HC-SB-61-346

**Propeller - Pitch Change Knob Inspection, Rework, and
Introduction of an Improved Pitch Change Knob Bracket**

January 05, 2023

This page transmits Revision 3 to Service Bulletin HC-SB-61-346.

Pitch Change Knob Bracket That Uses a Swaged Washer to Retain the Cam Follower
Figure 1

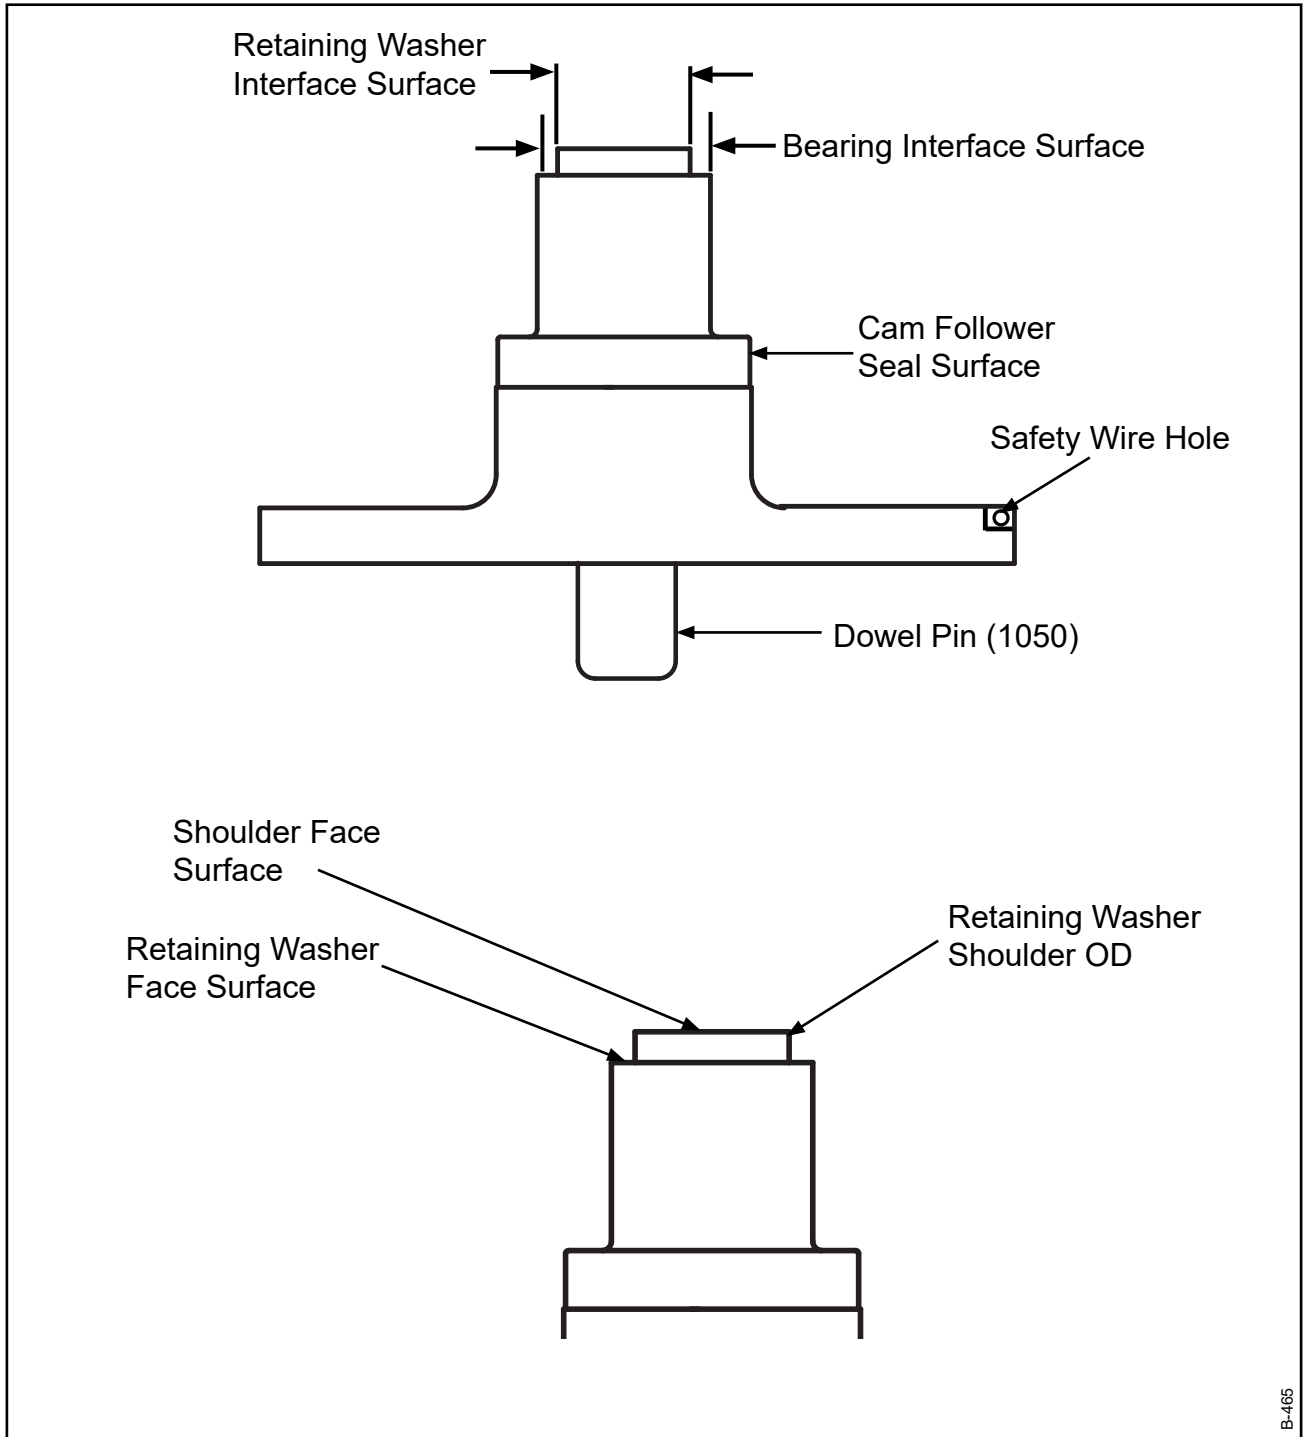
(8)	Measure the OD of the unplated retaining washer interface surface. Refer to Figure 1.	The minimum permitted OD of the unplated the retaining washer interface surface is 0.5005 inch (12.713 mm).	If the OD of the unplated retaining washer interface surface is less than the serviceable limits, replace the pitch change knob bracket or modify the pitch change knob bracket to use a screw to retain the cam follower in accordance with the section "Pitch Change Knob Bracket Modification" in this Service Bulletin.

(9) Visually examine the retaining washer interface surface for damage, corrosion, or pitting. Refer to Figure 1.	Minor scratches less than 0.001 inch (0.025 mm) deep are permitted. A sharp edge, material protrusion, or raised material from scratches or swaging are not permitted. Corrosion or pitting is not permitted.	Using an emery cloth or abrasive pad CM47, lightly polish to remove a sharp edge, material protrusion, or raised material and blend into machined surfaces. If the damage, corrosion, or pitting is greater than the permitted serviceable limits, replace the pitch change knob bracket or modify the pitch change knob bracket to use a screw to retain the cam follower in accordance with the section "Pitch Change Knob Bracket Modification" in this Service Bulletin.

(10) Visually examine the bearing interface surface for damage, corrosion, or pitting. Refer to Figure 1.	Bearing roller impressions of any depth are not permitted. Minor scratches less than 0.001 inch (0.025 mm) deep are permitted. Sharp edges or pushed up edges from scratches are not permitted. Corrosion or pitting is not permitted.	If the damage, corrosion, or pitting is greater than the permitted serviceable limits, replace the pitch change knob bracket.

(11) Measure the OD of the unplated bearing interface surface. Refer to Figure 1.	The minimum permitted OD of the unplated bearing interface surface is 0.653 inch (16.59 mm).	If the OD of the unplated bearing interface surface is less than the serviceable limits, replace the pitch change knob bracket.

**Pitch Change Knob Bracket That Uses a Swaged Washer to Retain the Cam Follower
Figure 2**

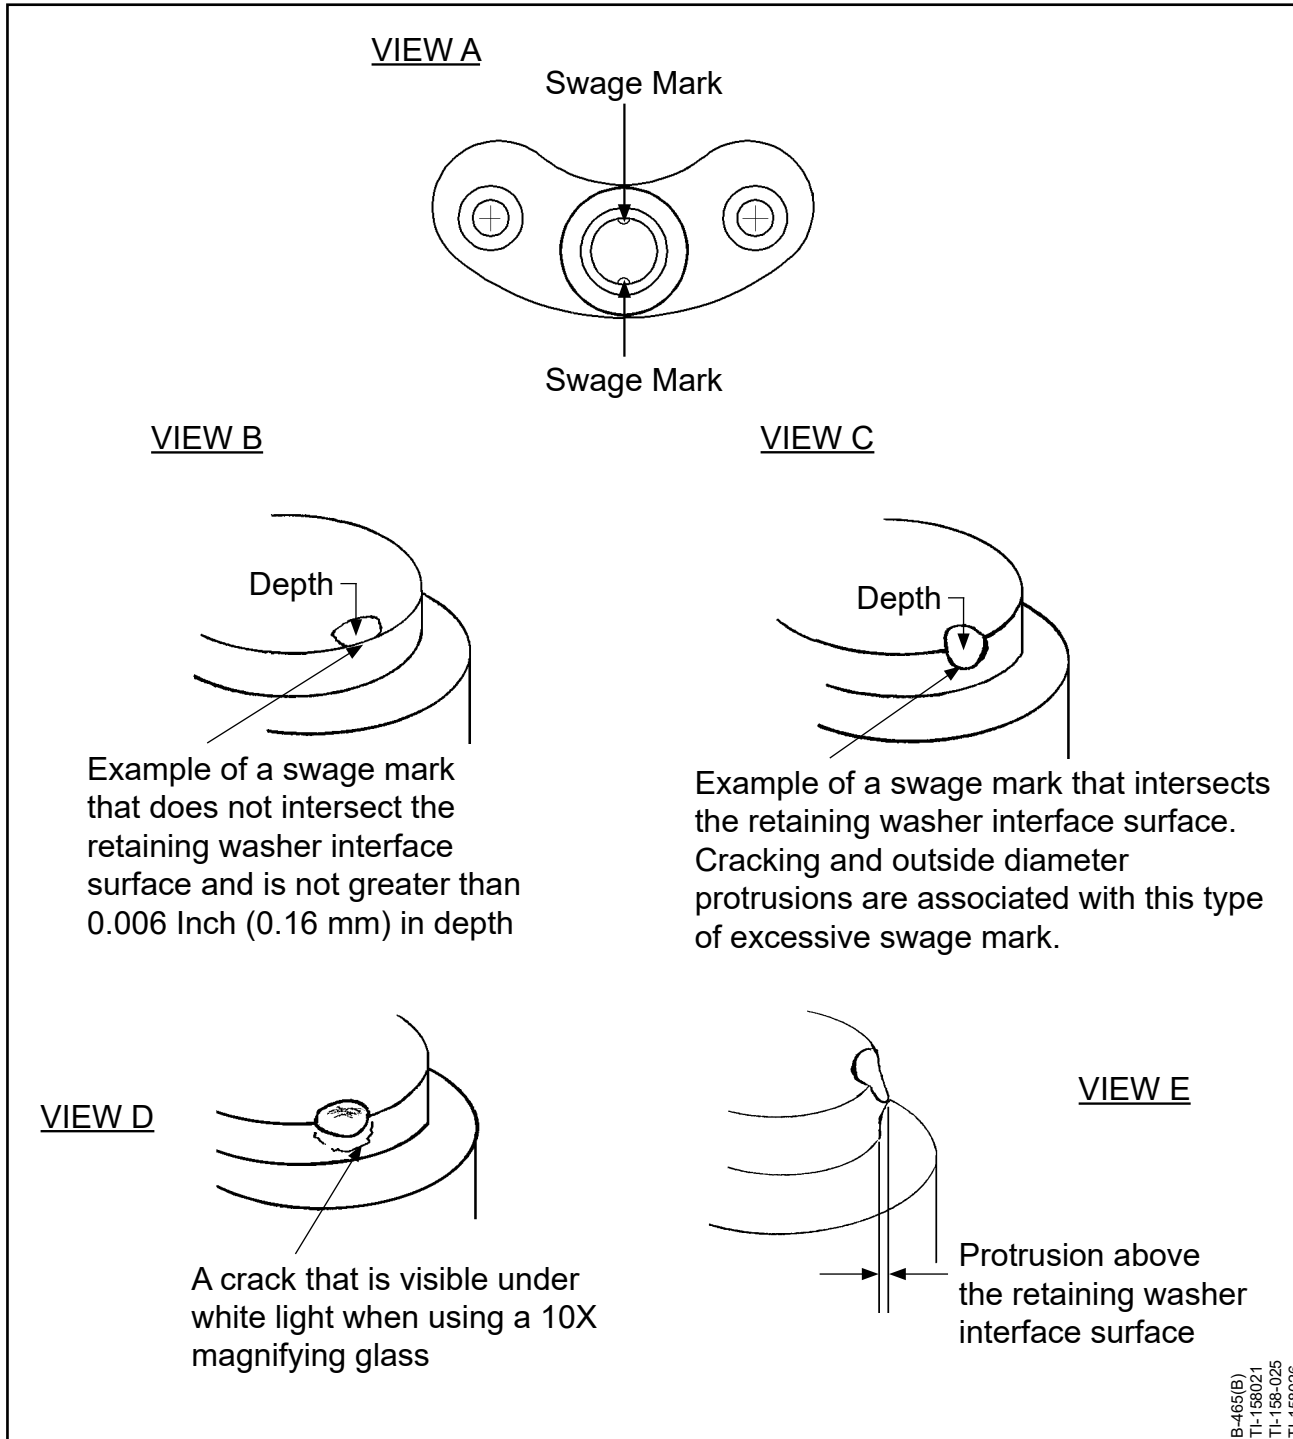
(3) An example of correct swaging is shown in Figure 2, View B. An example of incorrect swaging is shown in Figure 2, View C.		
(4) A pitch change knob bracket that does not meet the Serviceable Limits specified in step A.(5), A.(6), A.(7), A(8), or A(9) may be modified in accordance with the section "Pitch Change Knob Bracket Modification" in the 3.C. of this Service Bulletin.

(5) Using white light and a 10X magnifying glass, visually examine each swage mark on the retaining washer shoulder OD of the pitch change knob bracket for cracks.	A crack is not permitted. Refer to Figure 2, View D.	A crack may be removed by spot polishing using an emery cloth or abrasive pad CM47. Crack removal must not interfere with the retaining washer face surface or be greater than 25% of the retaining washer shoulder OD in one location. Refer to Figure 1 and Figure 3, View C. Total accumulated damage or repair must not be greater than 50% of the circumference of the retaining washer shoulder OD. Refer to Figure 3 View A. If the damage or repair is greater than the limits given, replace the pitch change knob bracket or modify the pitch change knob bracket to use a screw to retain the cam follower in accordance with the section "Pitch Change Knob Bracket Modification" in this Service Bulletin.

(6)	Visually examine each swage mark on the retaining washer shoulder OD and the retaining washer interface surface for material protrusion. Refer to Figure 2 View E.	Material protrusion is not permitted above the retaining washer interface surface.	If there is material protrusion, using an emery cloth remove the material protrusion to flush or below the surface of the retaining washer interface surface or modify the pitch change knob bracket to use a screw to retain the cam follower in accordance with the section "Pitch Change Knob Bracket Modification" in this Service Bulletin.

Pitch Change Knob Bracket That Uses a Swaged Washer to Retain the Cam Follower
Figure 3

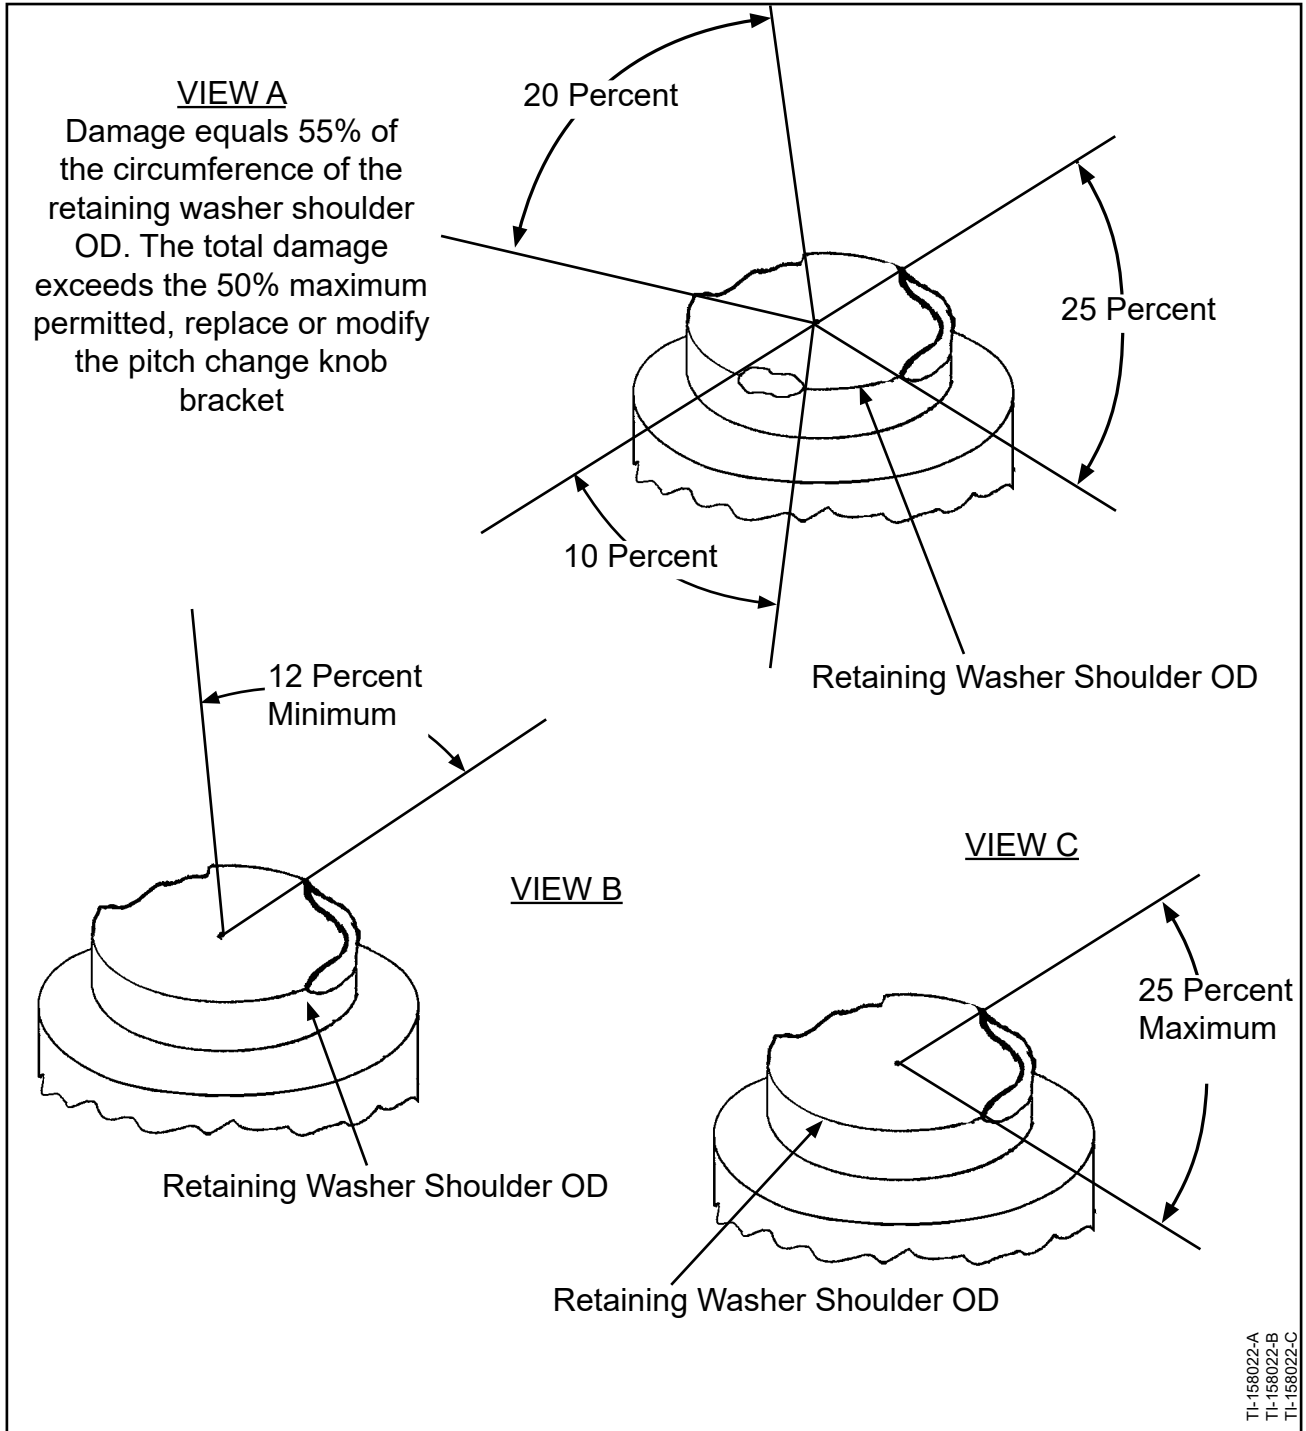
(7)	Visually examine the retaining washer shoulder OD for two undamaged swaging sites to secure the retention washer. Refer to Figure 3, View B.	Two unswaged areas that are a minimum width of 12 percent or 0.188 inch (4.78 mm) of the circumference positioned 120 to 180 degrees apart from each other are required.	If the available swaging sites are not within the permitted serviceable limits, replace the pitch change knob bracket or modify the pitch change knob bracket to use a screw to retain the cam follower in accordance with the section "Pitch Change Knob Bracket Modification" in this Service Bulletin.

**Pitch Change Knob Bracket That Uses a Swaged Washer to Retain the Cam Follower
Figure 4**

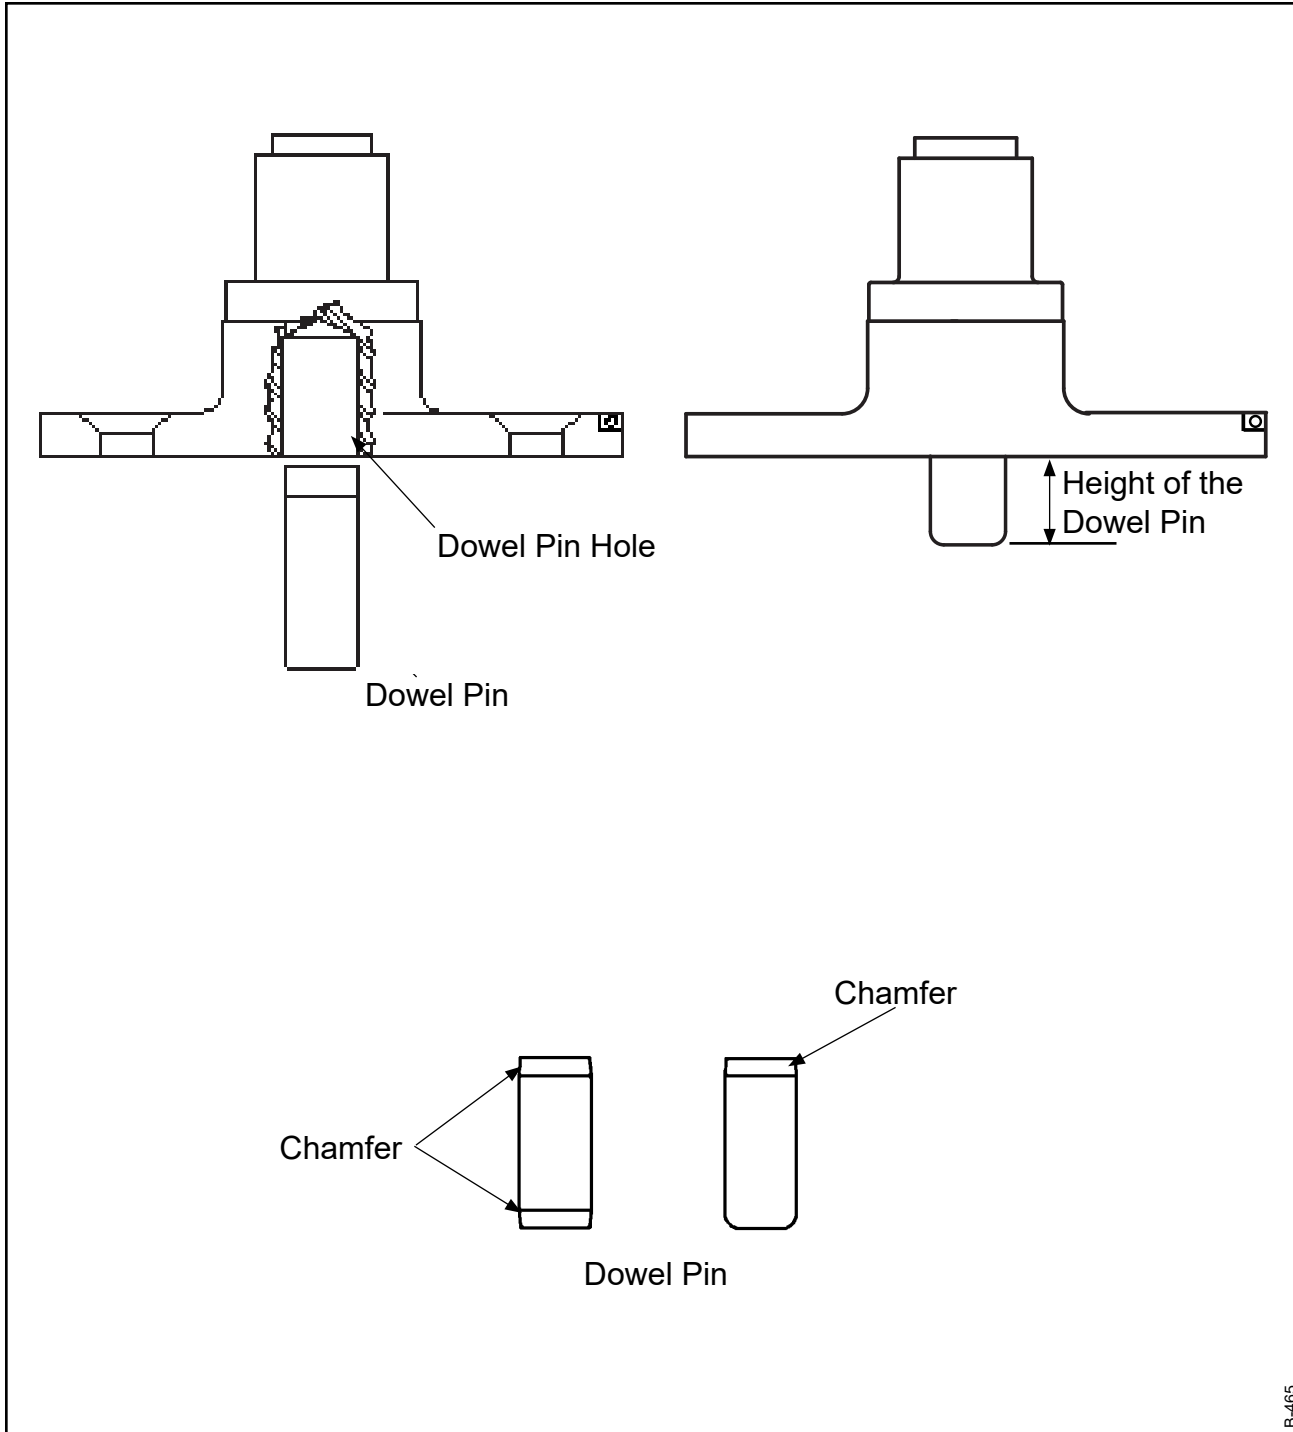
(17) Measure the height of the dowel pin from the pitch change knob bracket base. Refer to Figure 4.	The maximum permitted height is 0.440 inch (11.17 mm). The minimum permitted height is 0.390 inch (9.91 mm).	If the height of the dowel pin is greater than the permitted height, press the pin into the bracket to the correct height. If height of the dowel pin is less than the permitted serviceable limits, replace the pin. The replacement pin must fit tightly.

(19) If the dowel pin is removed, visually examine the dowel pin hole. Refer to Figure 4.	Corrosion or pitting is not permitted.	If there is corrosion or pitting, replace the pitch change knob bracket.

**Pitch Change Knob Bracket that Uses a Screw to Retain the Cam Follower
Figure 5**

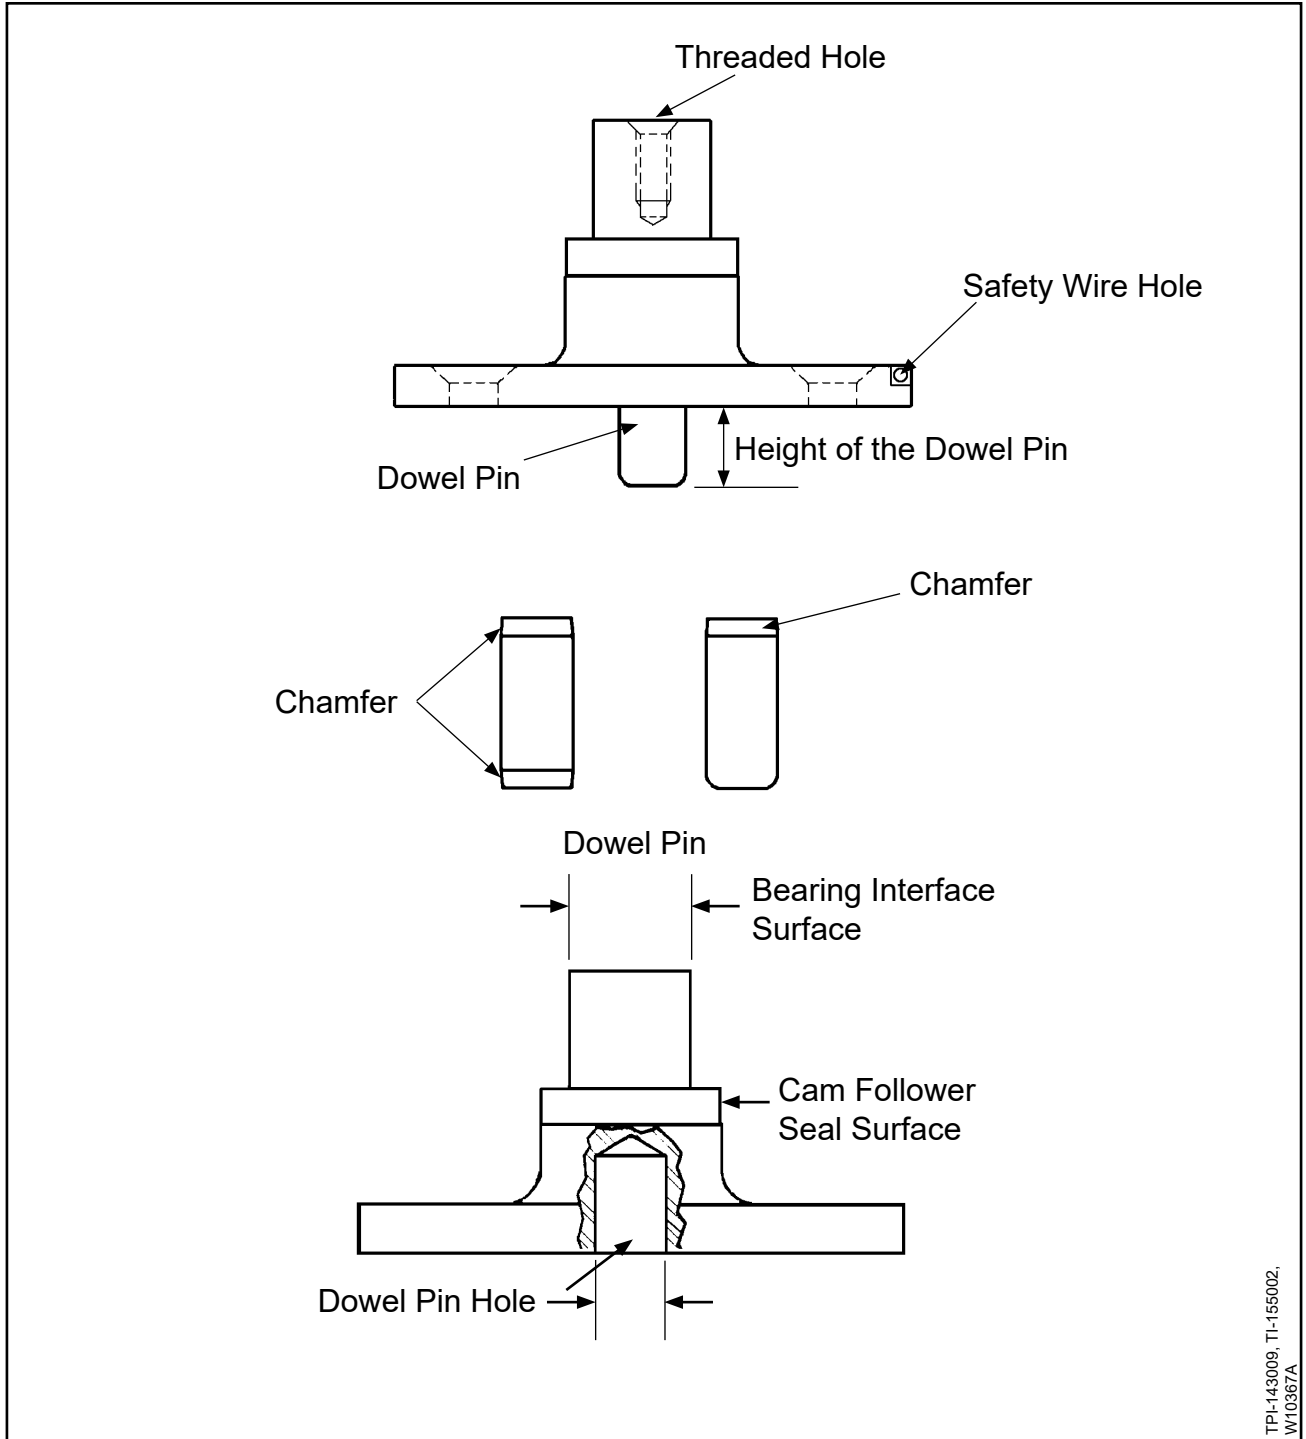
(3)	Visually examine the bearing interface surface for damage, corrosion, or pitting. Refer to Figure 5. Bearing roller impressions of any depth are not permitted. Minor scratches less than 0.001 inch (0.025 mm) deep are permitted. Sharp edges or pushed up edges from scratches are not permitted. Corrosion or pitting is not permitted.	If the damage, corrosion, or pitting is greater than the permitted serviceable limits, replace the pitch change knob bracket.

(4)	Measure the OD of the unplated bearing interface surface. Refer to Figure 5. The minimum permitted OD of the unplated bearing interface surface is 0.653 inch (16.59 mm).	If the OD of the unplated bearing interface surface is less than the serviceable limits, replace the pitch change knob bracket

(5)	Visually examine the cam follower seal surface for scratches, corrosion, or pitting. Refer to Figure 5. Minor scratches less than 0.001 inch (0.025 mm) deep are permitted. Sharp or pushed up edges from scratches are not permitted. Corrosion or pitting is not permitted.	If the scratches, corrosion, or pitting is greater than the permitted serviceable limits, replace the pitch change knob bracket.

Inspect	Serviceable Limits	Corrective Action
B. <u>PITCH CHANGE KNOB BRACKET THAT USES A SCREW TO RETAIN THE CAM FOLLOWER</u> (Refer to Figure 5)		
(10) Measure the height of the dowel pin from the pitch change knob bracket base. Refer to Figure 5.	The maximum permitted height is 0.440 inch (11.17 mm). The minimum permitted height is 0.390 inch (9.91 mm).	If the height of the dowel pin is greater than the permitted height, press the pin into the bracket to the correct height. If height of the dowel pin is less than the permitted serviceable limits, replace the pin. The replacement pin must fit tightly.
